Project	IEEE 802.16 Broadband Wireless Access Working Group < http://ieee802.org/16 >	
Title	Uplink sub-channelization modifications for OFDMA PHY mode	
Date Submitted	2004-04-15	
Source(s)	<p>Panyuh Joo, Seungjoo Maeng, Jaeho Jeon, panyuh@samsung.com Soonyoung Yoon, Jeong-Heon Kim, Jaehyok Lee, Myungkwang Byun, Inseok Hwang, yigall@runcom.co.il Jaehee Cho, Jiho Jang, Sanghoon Sung, Samsung Electronics Co. Ltd. lim@etri.re.kr</p> <p>Yigal Leiba, Zion Hadad, Yossi Segal, Itzik Kitroser Runcom Technologies</p> <p>Choongil Yeh, Hyoungsoo Lim, Yuro Lee, Jongee Oh, DongSeung Kwon, ETRI</p>	
Re:	Sponsor re-circulation Ballot	
Abstract	Uplink sub-channelization modifications for OFDMA PHY mode	
Purpose	Adoption of proposed changes into P802.16-REVd/D4-2004	
Notice	This document has been prepared to assist IEEE 802.16. It is offered as a basis for discussion and is not binding on the contributing individual(s) or organization(s). The material in this document is subject to change in form and content after further study. The contributor(s) reserve(s) the right to add, amend or withdraw material contained herein.

Figure 226-Description of an uplink tile

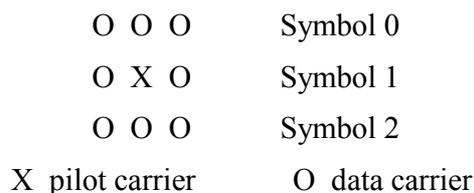
A burst in the uplink is composed of 3 time symbols and 1 subchannel, within each burst, there are 48 data subcarriers and 6 fixed-location pilot subcarrier. ~~File configuration~~ The subchannel is constructed from 6 uplink tiles, each tile has 3 subcarriers and it's configuration is illustrated in Figure 226.

Page 511, delete all the text below figure 226, change as follows:
